## ORIGINATION FORM

Proposed Revisions to a Standard Plans Index  
(Please provide all information — Incomplete forms will be returned)

Index Number: 450-199  
Sheet Number (s): Sheet 1  
Index Title: PRESTRESSED I-BEAMS BUILD-UP & DEF  
DATA

**BEAM CAMBER AND BUILD-UP NOTES:**

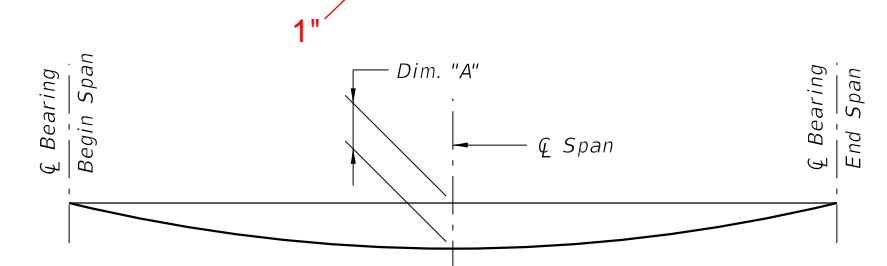
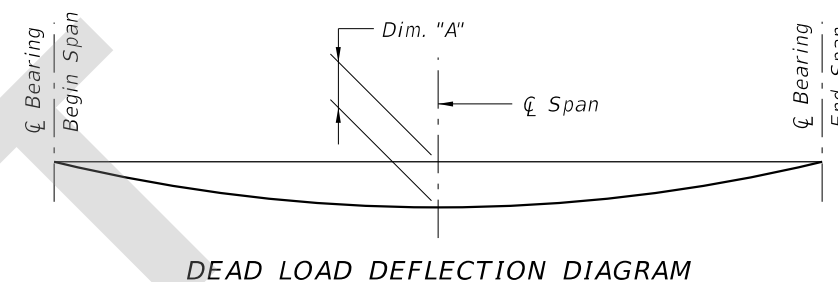
Change the camber tolerance 1" from 1/2".

The build-up values given in the Data Table\* are based on theoretical beam cambers. The Contractor shall monitor beam cambers for the purpose of predicting camber values at the time of the deck pour. If the predicted cambers based on field measurements differ more than  $\pm 1/2$ " from the theoretical "Net Beam Camber @ 120 Days" shown in the Data Table\*, obtain approval from the Engineer to modify the build-up dimensions as required. When the measured beam cambers create a conflict with the bottom mat of deck steel, notify the Engineer a minimum of 21 days prior to casting.

The build-up values given in the Data Table\* are based on theoretical beam cambers. The Contractor shall monitor beam cambers for the purpose of predicting camber values at the time of the deck pour. If the predicted cambers based on field measurements differ more than +/- 1" from the theoretical "Net Beam Camber @ 120 Days" shown in the Data Table\*, obtain approval from the Engineer to modify the build-up dimensions as required. When the measured beam cambers create a conflict with the bottom mat of deck steel, notify the Engineer a minimum of 21 days prior to casting.
